### ADDENDUM 1

## Austin Elementary School Heating & Air Condition (HVAC) Improvements Funded through the Elementary & Secondary Emergency Relief (ESSER) Funds May 31, 2022

## Addendum

**PROJECT** 218007.004 | Edinburg CISD - Stephen F. Austin ES - HVAC Improvements

**4** EXISTING A/C CLOSET - RESOURCE ROOM - DEMOLITION  
 MD3.01 1/2" = 1'-0"

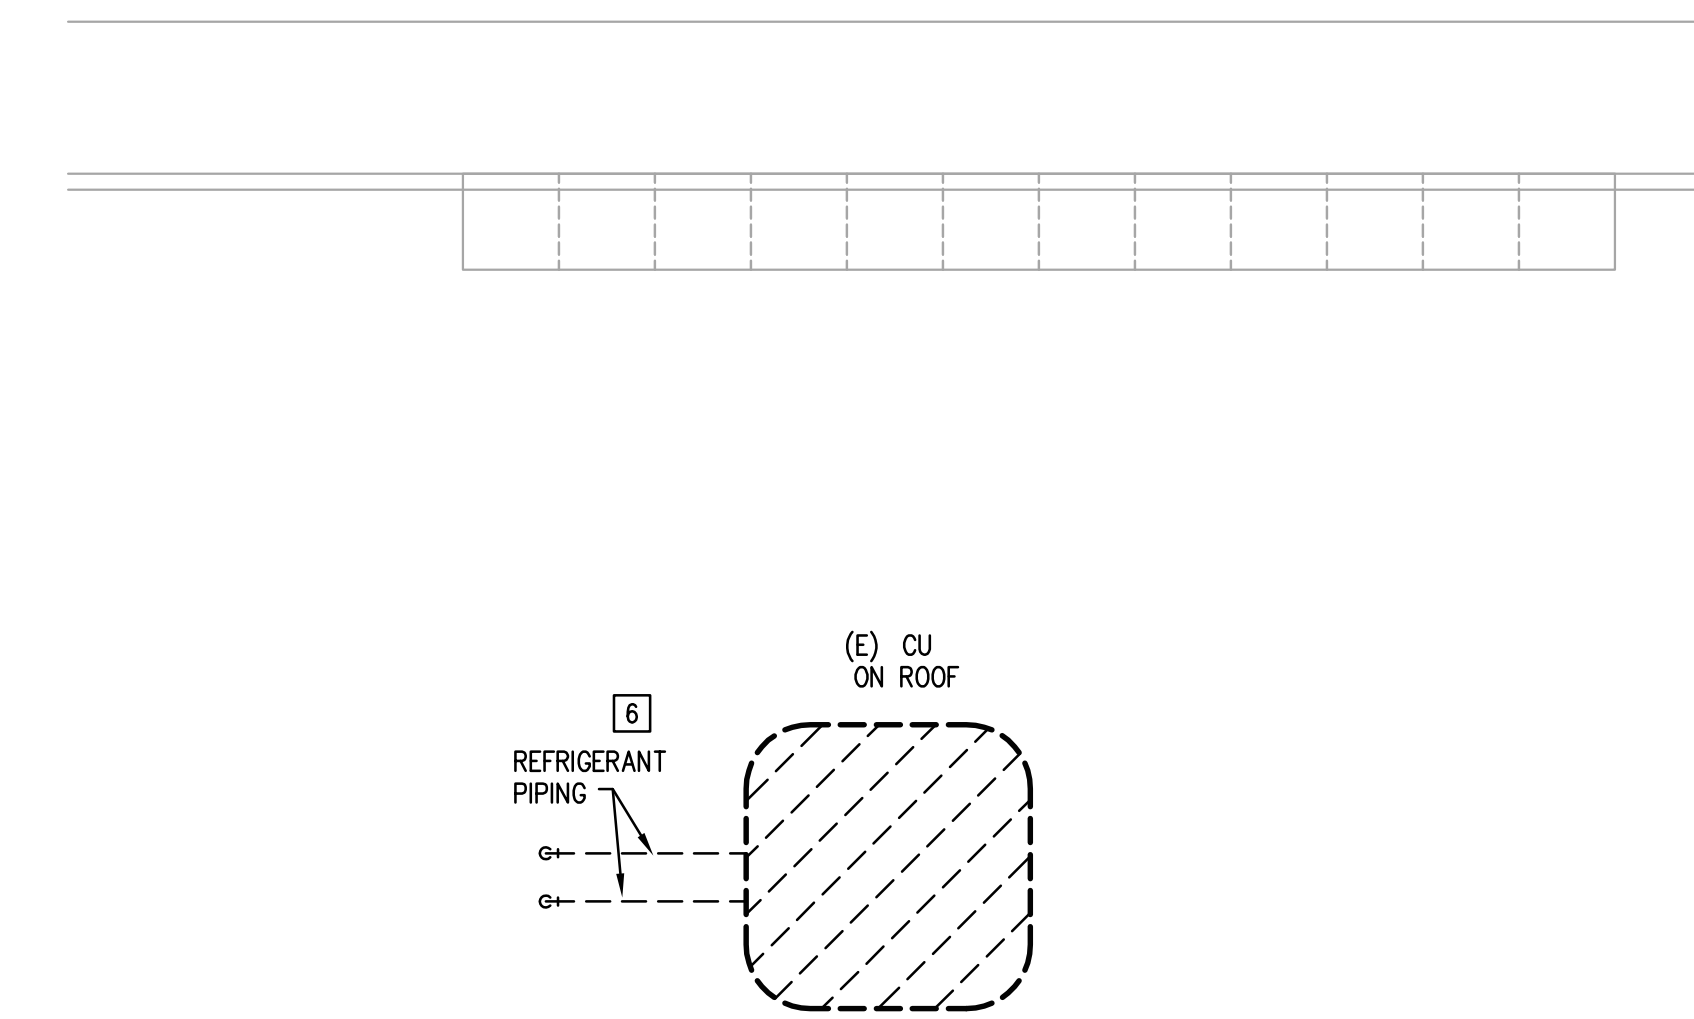
#### **Item 04 MD3.01 – Enlarged Mechanical Plans – Demolition**

- A. Revised keyed notes 1, 4, and 6.

SHEET NUMBER: MD3.02

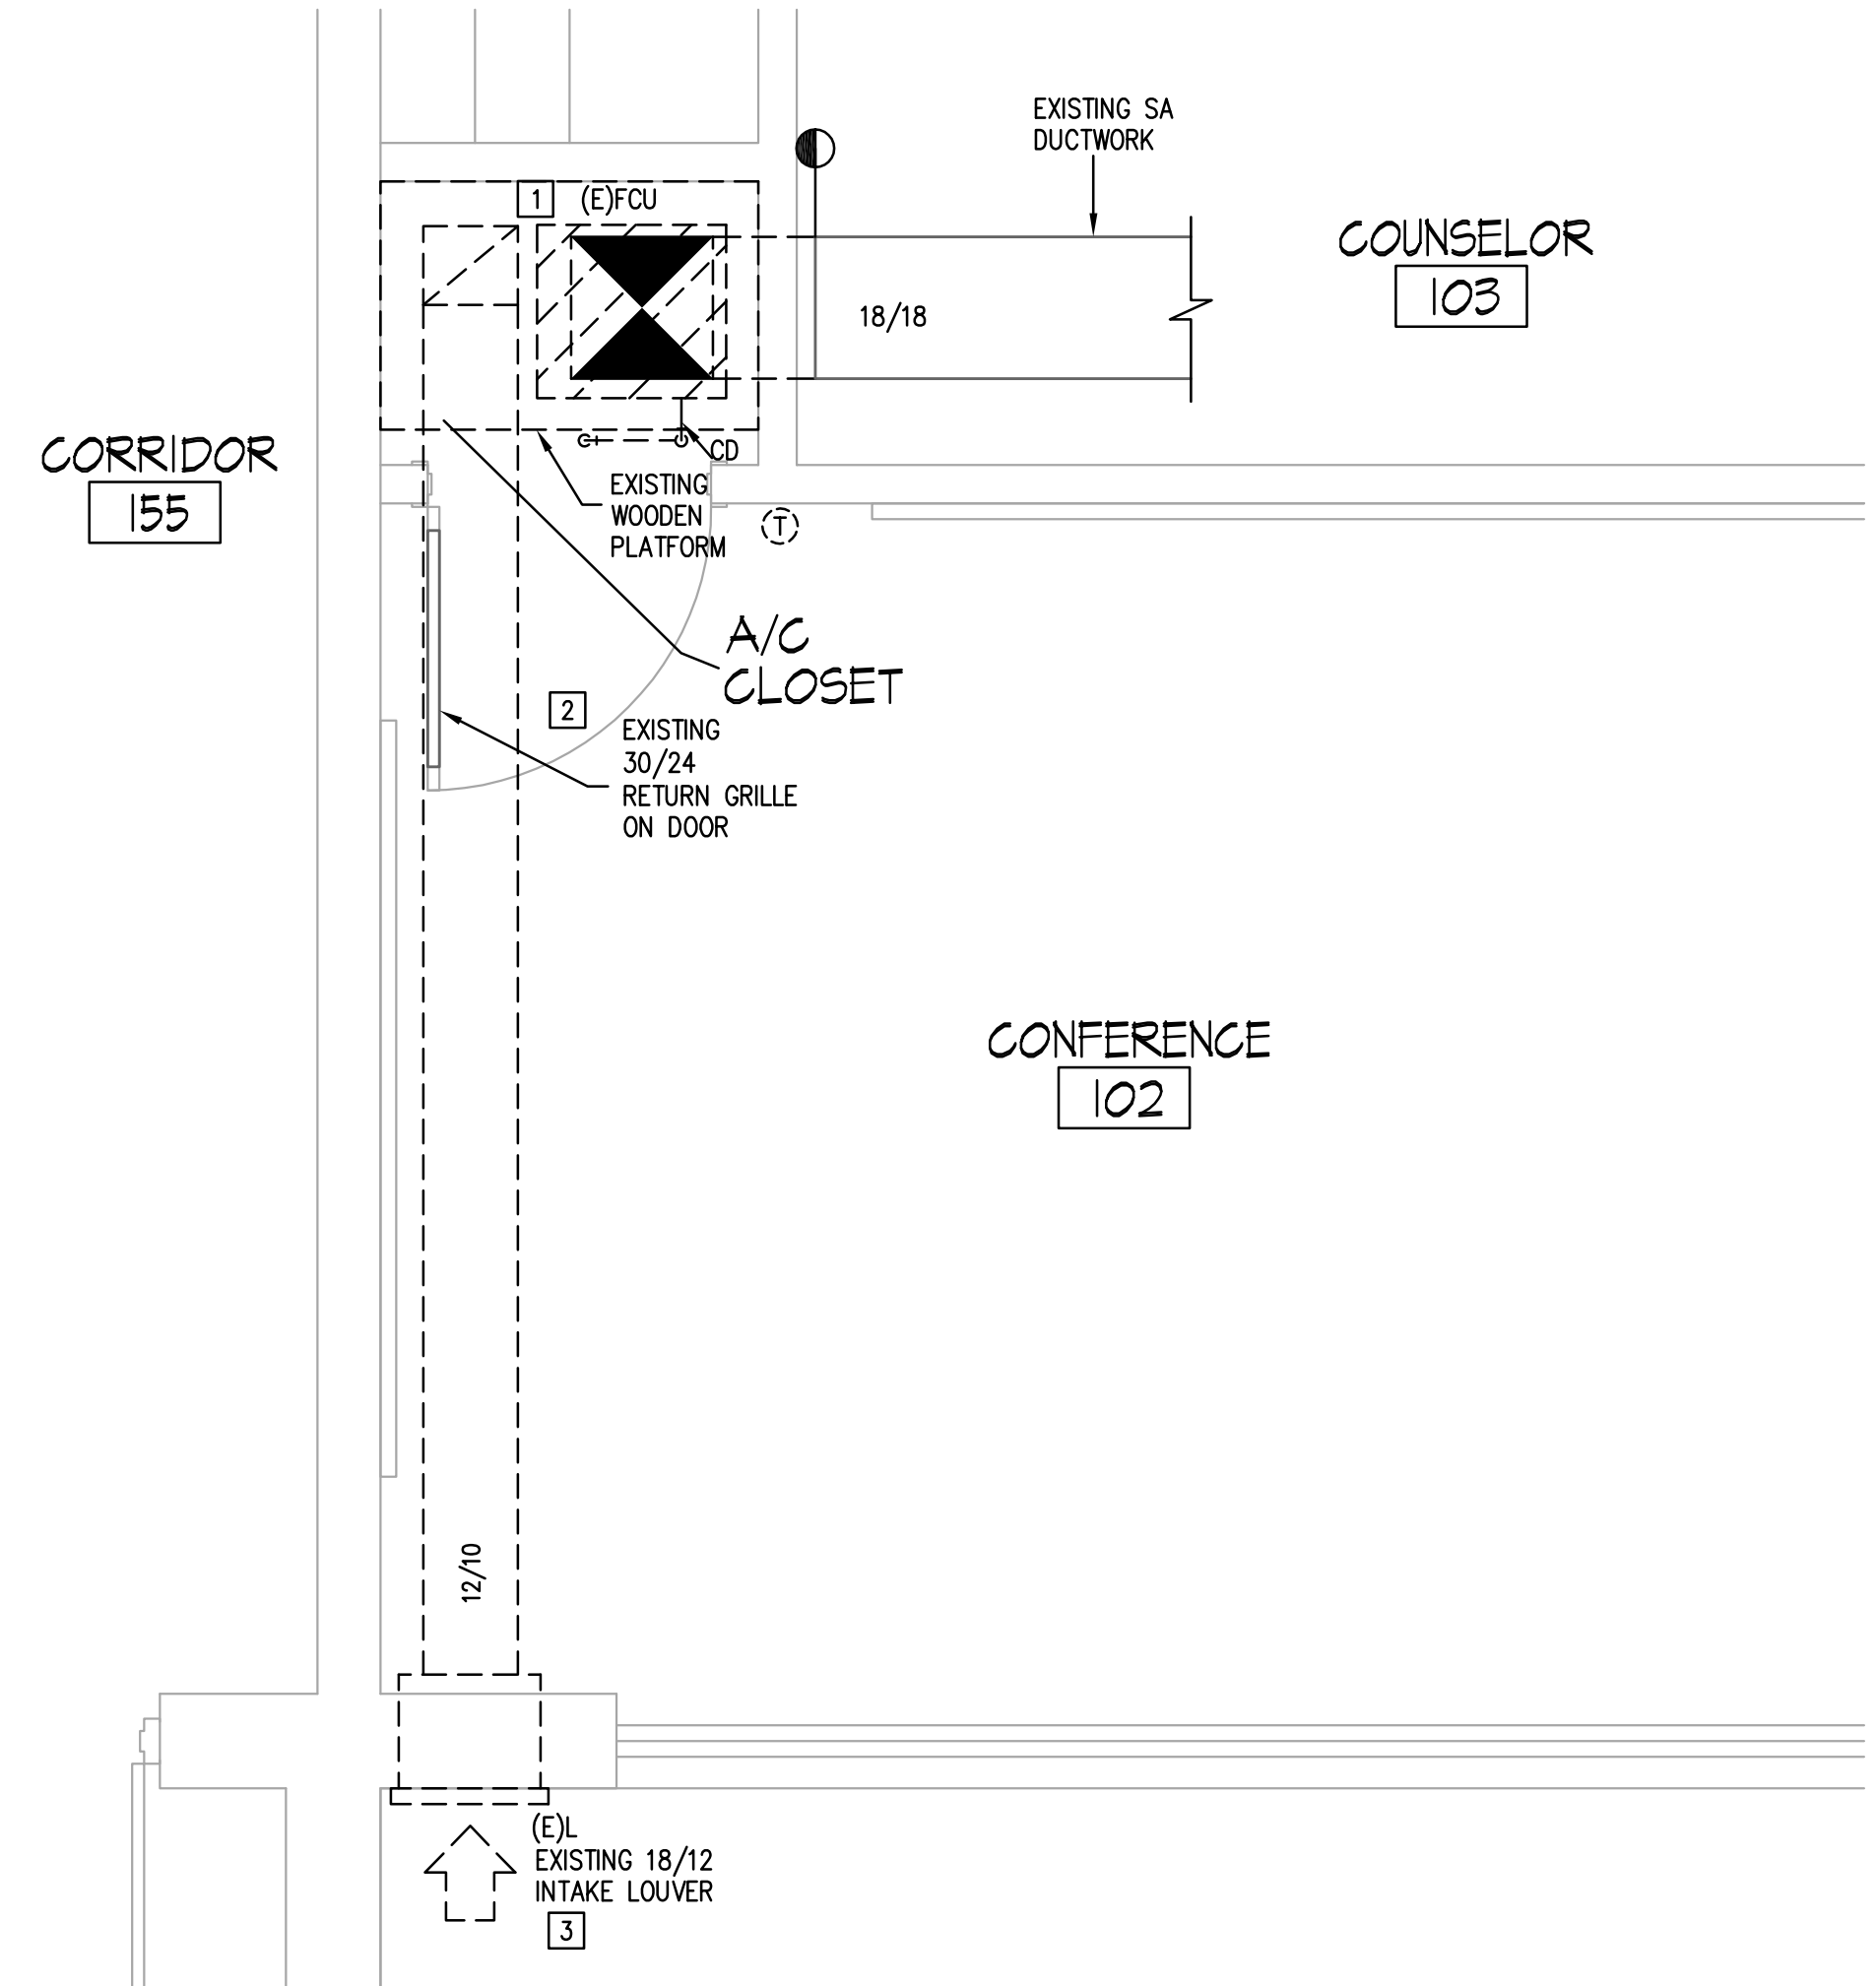
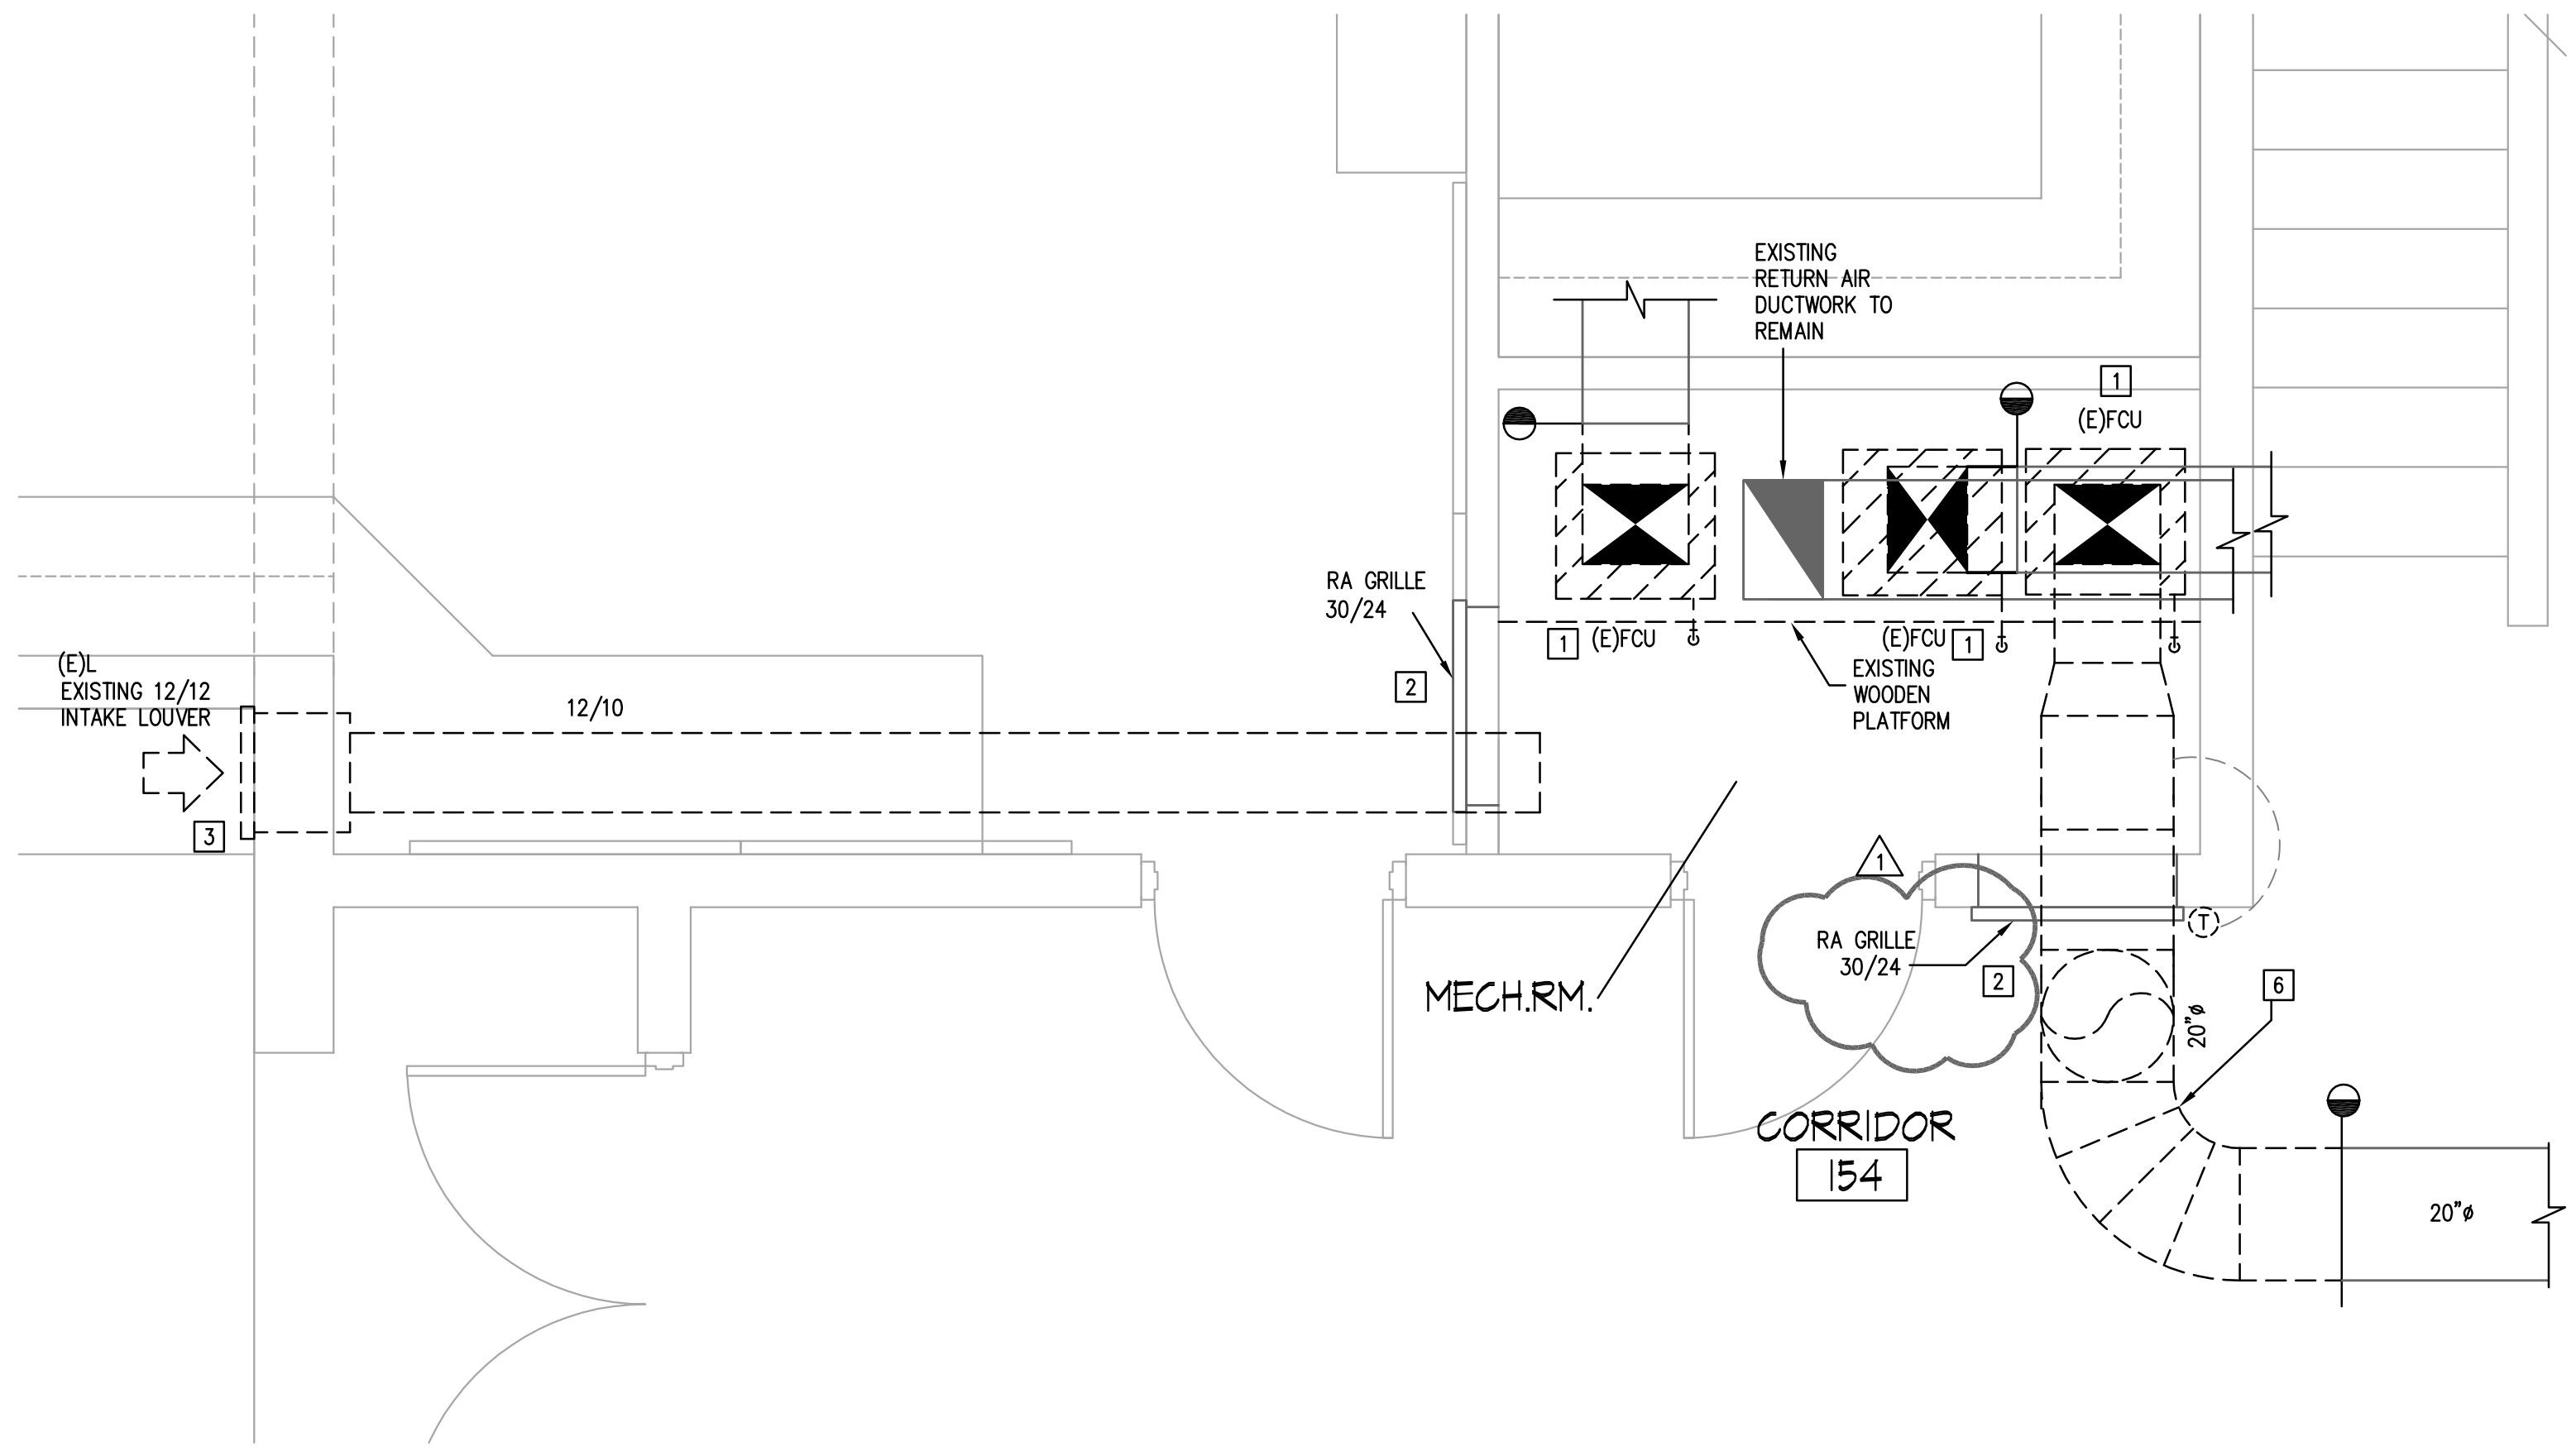
#### **Item 05 MD3.02 – Enlarged Mechanical Plans – Demolition**

- A. Revised keyed notes 1, 4, 5, 6.  
B. Added keyed note 2 to RA Grille in 3/MD3.02.
